## Rearview Camera Noise Optimization

Topic number	LI54.71-P-080180
Version	1
Function group	54.71 - Camera and radar-assisted assistance systems
Date	1/20/26
Validity	167 Facelift (GLE) with the following:  - Model Year 2024 and later (Option code 804, 805, etc...)  - Option Code 491 (Steel Spring Variant)  - Option Code 235 (PARKTRONIC with Active Parking Assist)
Reason for change

View PRIOR to SCN Coding:

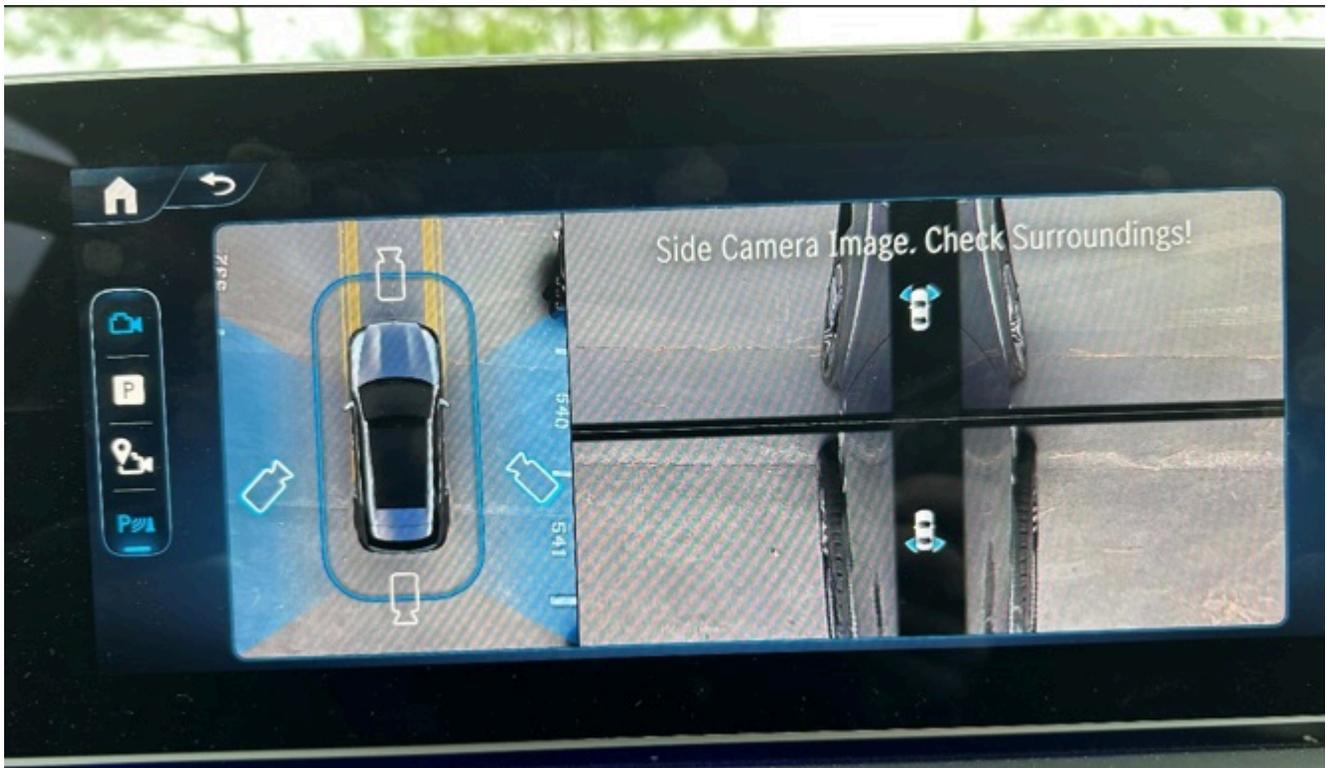
**IMPORTANT:** After both control units have been SCN coded, the "Movable 3D View" feature in the head unit will no longer be available. With this change there will be two distinct differences:

- 1) The "3D" icon when in the top down vehicle view, will no longer be present on the head unit.
- 2) The digital rendering of the vehicle with the ability to spatially move around the vehicle is no longer possible. This view is replaced with 2D static images of the left and right sides.

- Rear camera flap when calibrating after a key cycle bus sleep will stay open to 29 MPH and then close. Will re-open, when calibrating, at 9 MPH.
- The head unit screens mentioned above appear the same as "View AFTER SCN Coding" as shown in the attachment.
